# Access Compliance Report

## Public Rights-of-Way

Intersection ID: 28768	Main Street: FOUNTAINGROVE_DR	Cross Street: MAYCROFT_DR	Location:	N
ADA ID: 0ABBA838A843	Ramp Type: Perp	Initial Pass/Fail: Fail	Overall Compliance: No	Severity Score: 42.5
Codes/Mitigation Info/Possible Solution		Field Measurements/Component Compliance

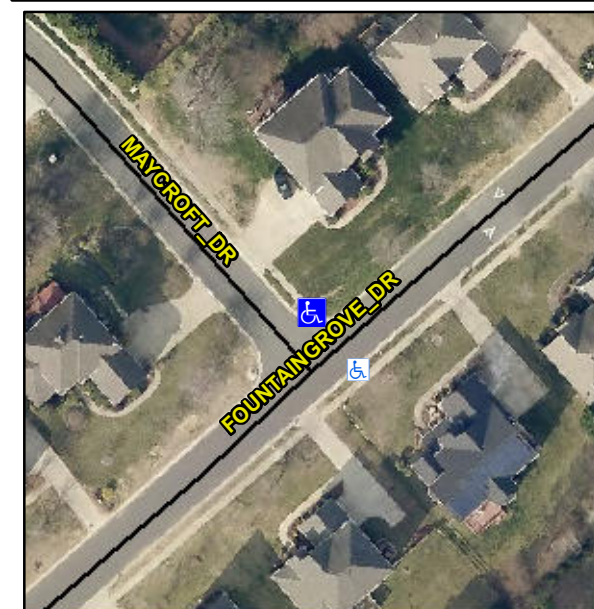
**R304.5.1, R304.2.2, R304.5.3**

Compliance	Description	Data	Compliance	Description	Data
N/A	Ramp Length (in)	32.0	No	Ramp Slope (%)	9.7
No	Ramp Width (in)	34.0	No	Ramp XSlope (%)	6.5
N/A	Flare Type LT	N/A	N/A	Flare Type RT	N/A
N/A	Flare Slope LT (%)	N/A	N/A	Flare Slope RT (%)	N/A
N/A	Flare Traversable LT?	N/A	N/A	Flare Traversable RT?	N/A
N/A	Landing Length (in)	N/A	N/A	DWS Provided?	N/A
N/A	Landing Width (in)	N/A	N/A	DWS Contrast?	N/A
N/A	Landing Slope (%)	N/A	N/A	DWS Length (in)	N/A
N/A	Landing X Slope (%)	N/A	N/A	DWS Full Width?	N/A
N/A	Landing Curb? (Y/N)	N/A	N/A	DWS Offset (in)	N/A
N/A	Shared Landing?	N/A			
N/A	Gutter Ponding?	N/A	N/A	Gutter Slope (%)	N/A
N/A	Gutter Lip Ht (in)	N/A	N/A	Gutter X Slope (%)	N/A
N/A	Painted X Walk1?	No	N/A	Painted X Walk2?	N/A
	X Walk 1 Direction	To SE		X Walk 2 Direction	N/A
N/A	X Walk 1 Width (in)	N/A	N/A	X Walk 2 Width (in)	N/A
	X Walk 1 Slope (%)	3.2		X Walk 2 Slope (%)	N/A
	X Walk 1 X Slope (%)	2.6		X Walk 2 X Slope (%)	N/A

**Remove & Replace Entire Ramp.**
